AGENDA
DESIGN COMMISSION
Community Room, 3rd Floor
Arlington Heights Village Hall, 33 S. Arlington Heights Rd.
Arlington Heights, IL 60005
May 13, 2025
6:30 PM

Design Commission
5/13/2025

Item: 832 N. Forrest Ave. / SF-Addition - DC25-029

Item: Slick City - 780 W. Dundee Rd. / Commercial - DC25-022

Proposed Addition For
Mr. Brett Kroner
832 N. Forrest
Arlington Hts., IL 60004

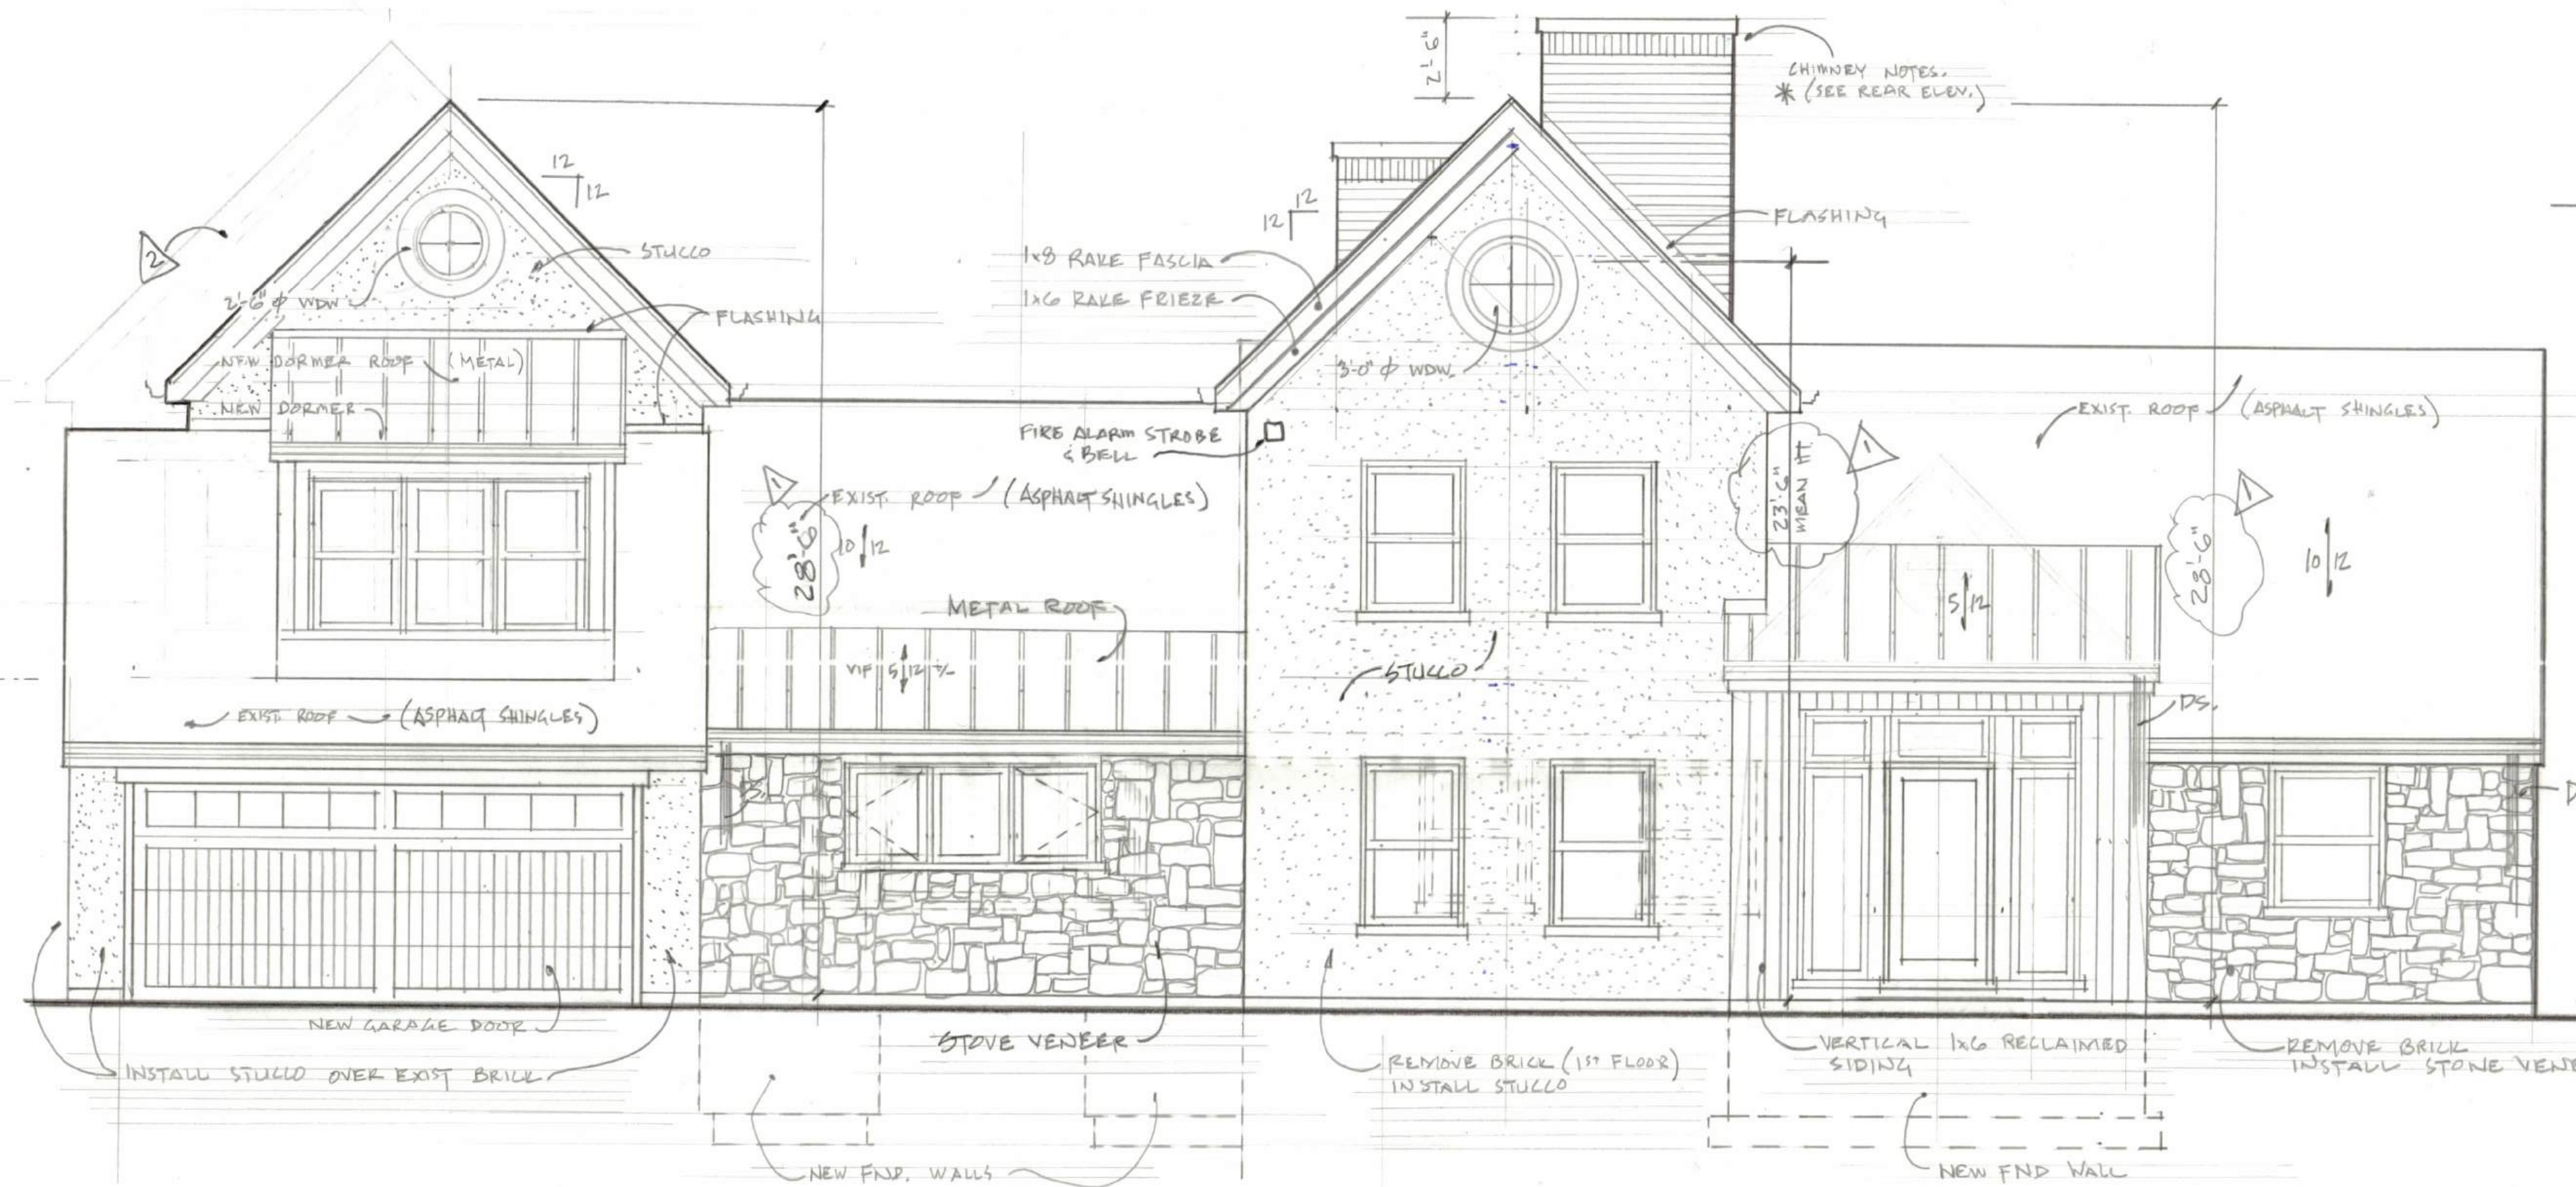
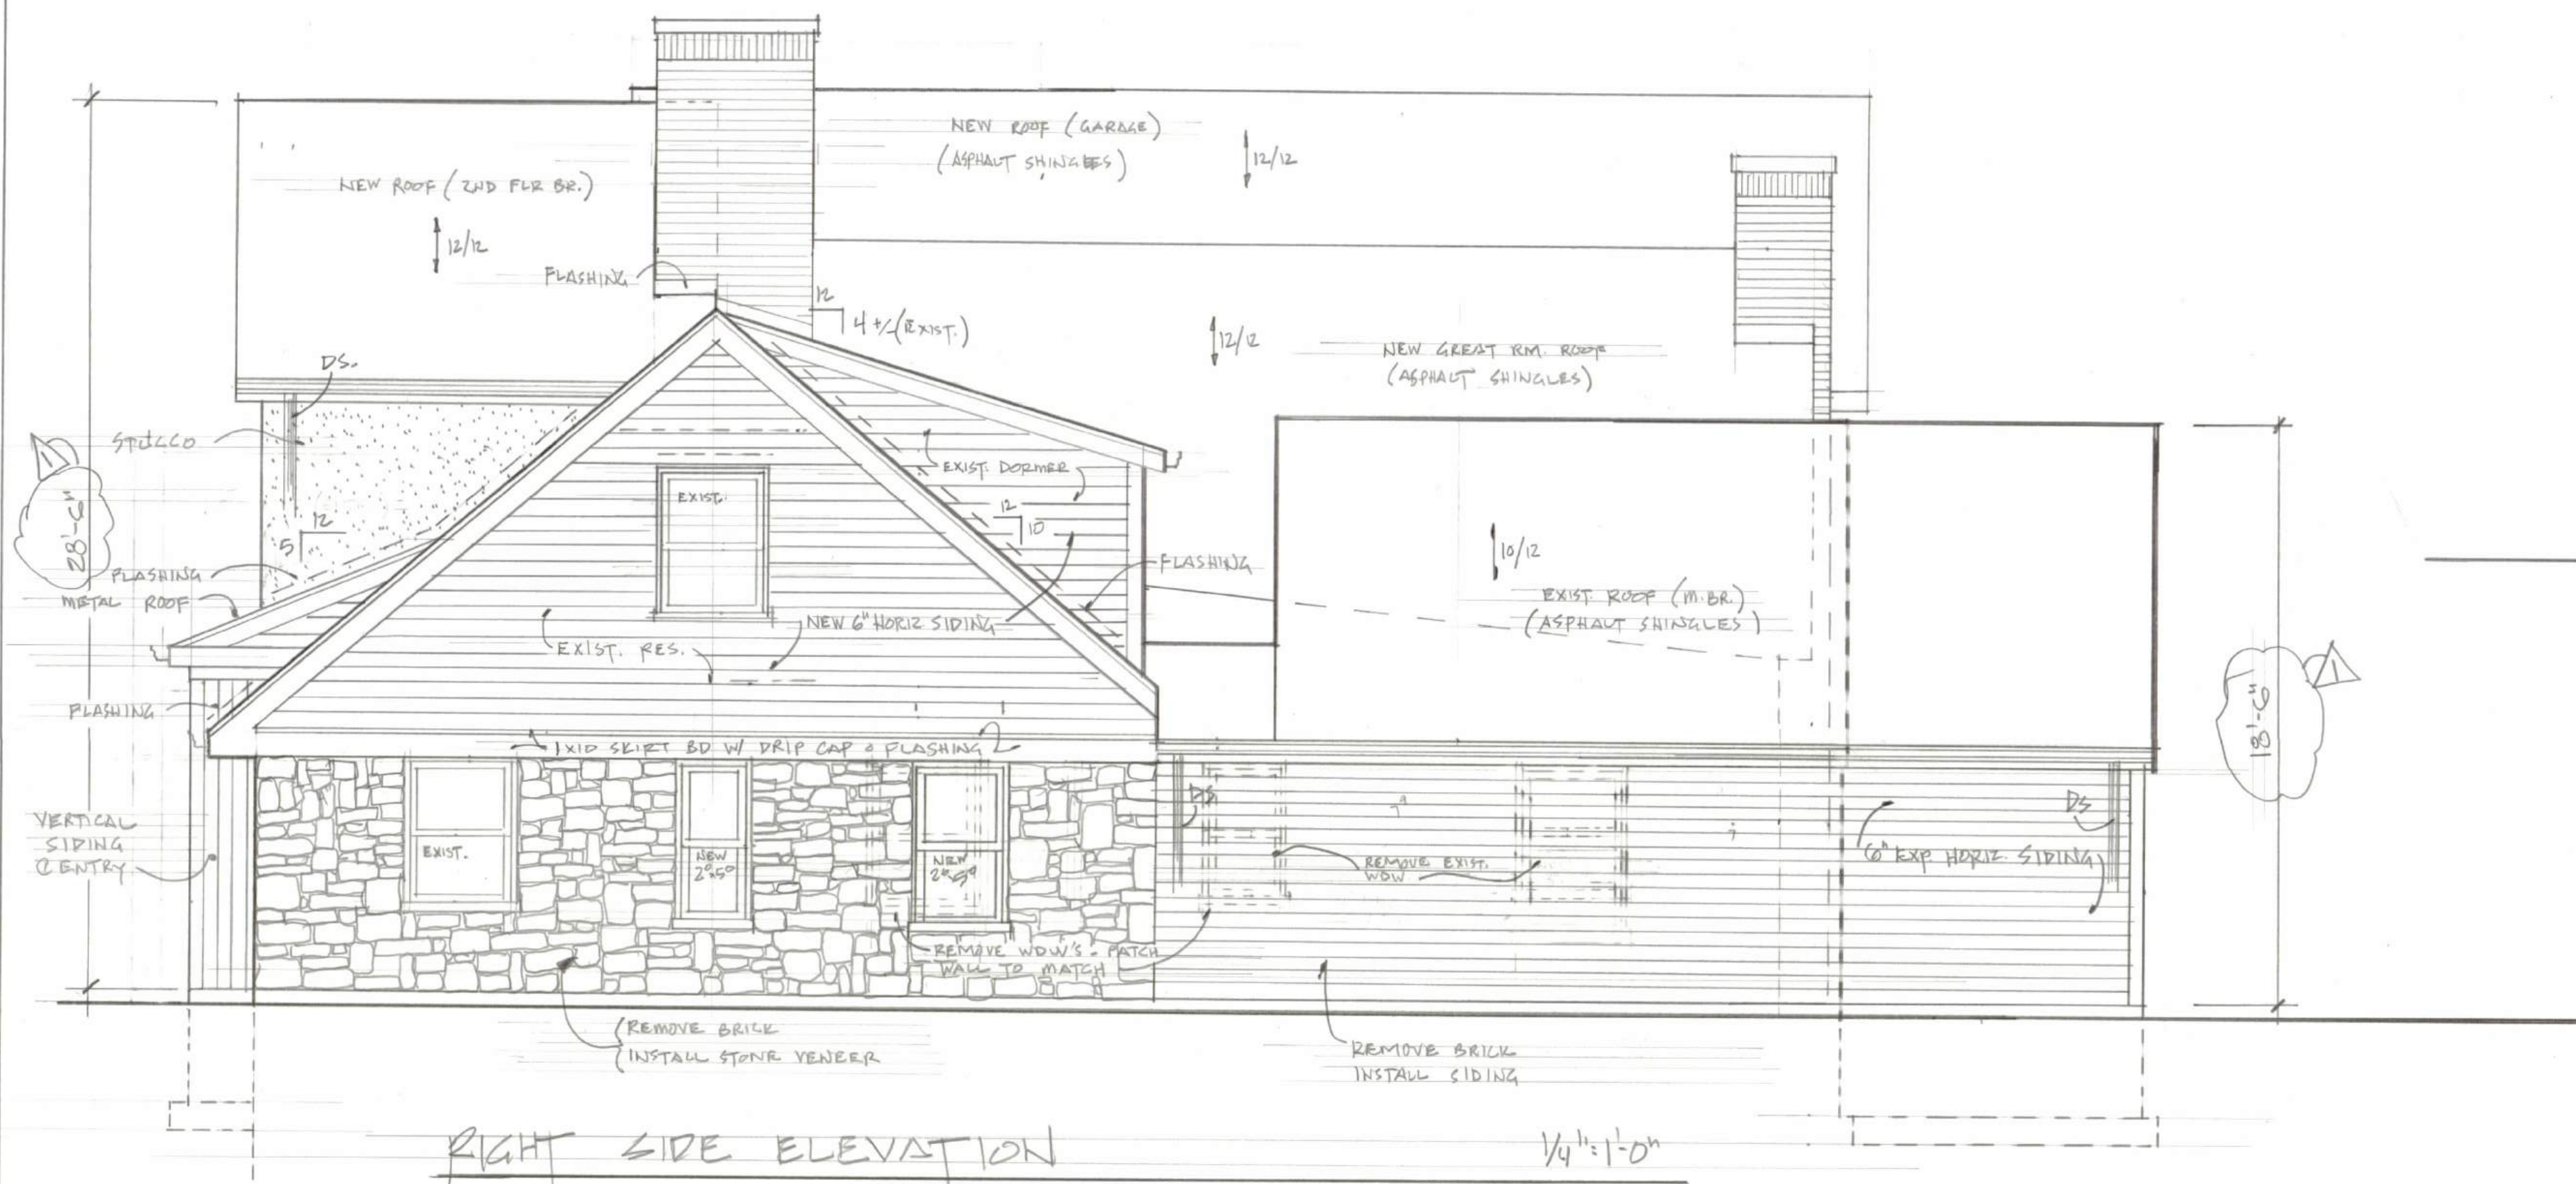
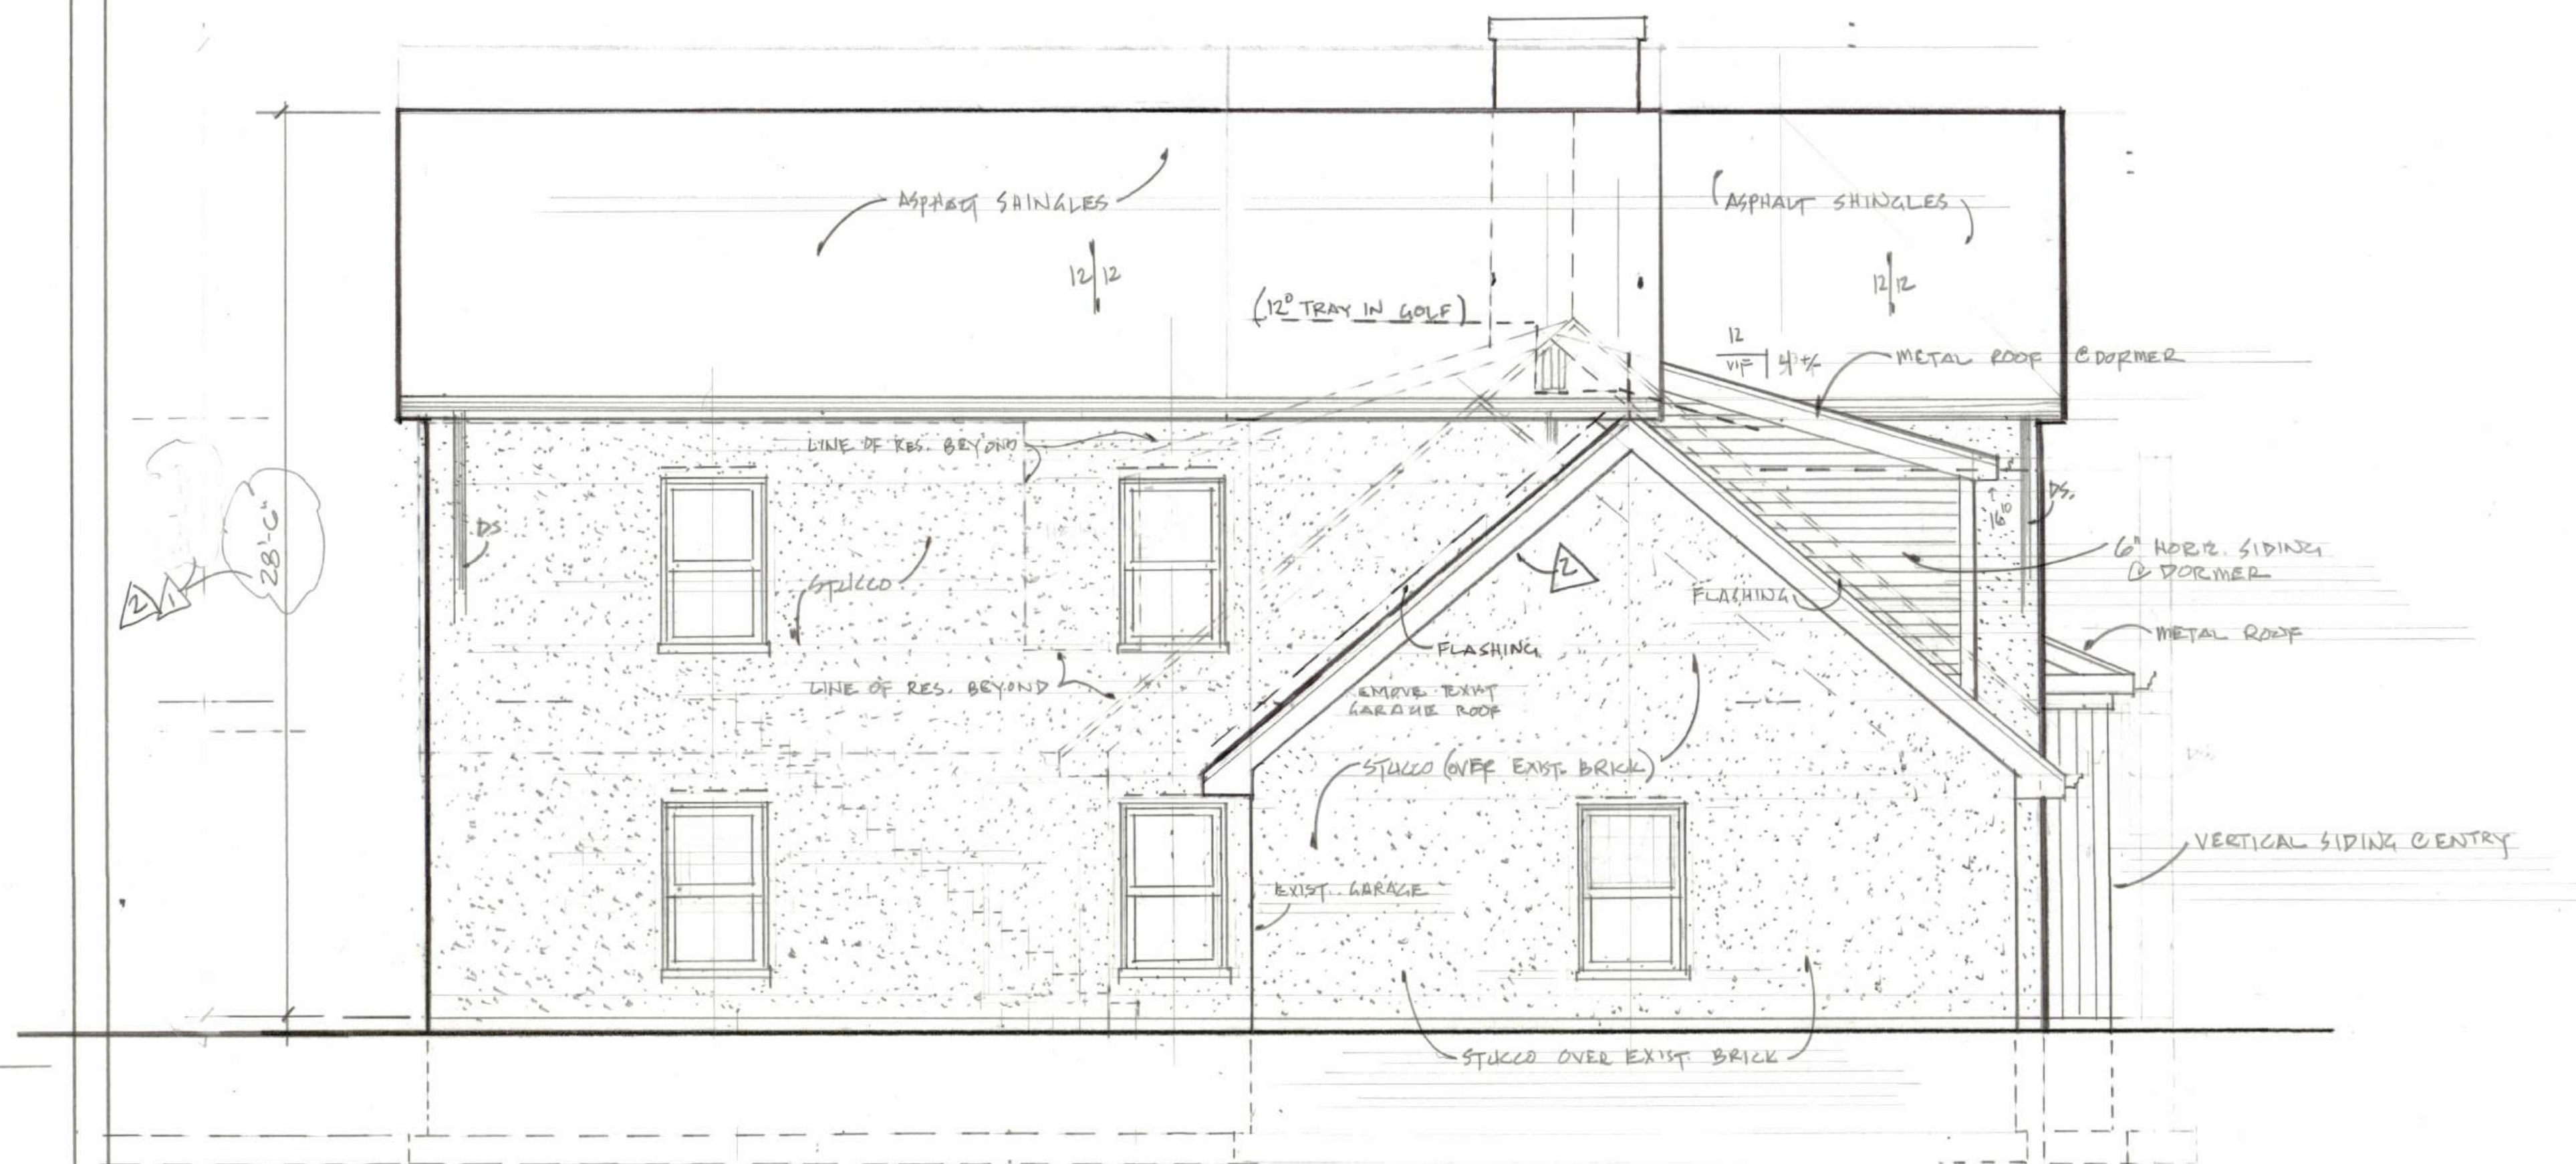
The subject property is on a street of large lots, where the minimum lots size is 20,000 sf and the minimum lot width is 100 feet. Many of the original homes on this street have either been expanded with additions or replaced with new larger two-story houses. The scale of the proposed expanded house fits comfortably on the large lot and with the surrounding context. However, the Design Commission should evaluate the massing of the proposed design which is unusual with an off-center dormer above the existing garage and a divided second floor. The proposed materials and colors for the house are also quite busy, with a combination of white horizontal siding, black vertical siding, white stucco, and buff limestone used on different parts of the house. The trim on the house is specified to be black, which is a bold look with white siding and white gutters. The Design Commission should evaluate the proposed massing and materials, which Staff recommends should be simplified for a more cohesive appearance.

1. A recommendation to simplify the proposed massing and materials/colors for a more cohesive appearance.
2. This review deals with architectural design only and should not be construed to be an approval of, or to have any other impact on, any other zoning and/or land use issues or decisions that stem from zoning, building, signage or any other reviews. In addition to the normal technical review, permit drawings will be reviewed for consistency with the Design Commission and any other Commission or Board approval conditions. It is the architect/homeowner/builder's responsibility to comply with the Design Commission approval and ensure that building permit plans comply with all zoning code, building permit and signage requirements.
3. Compliance with all applicable Federal, State, and Village codes, regulations and policies.
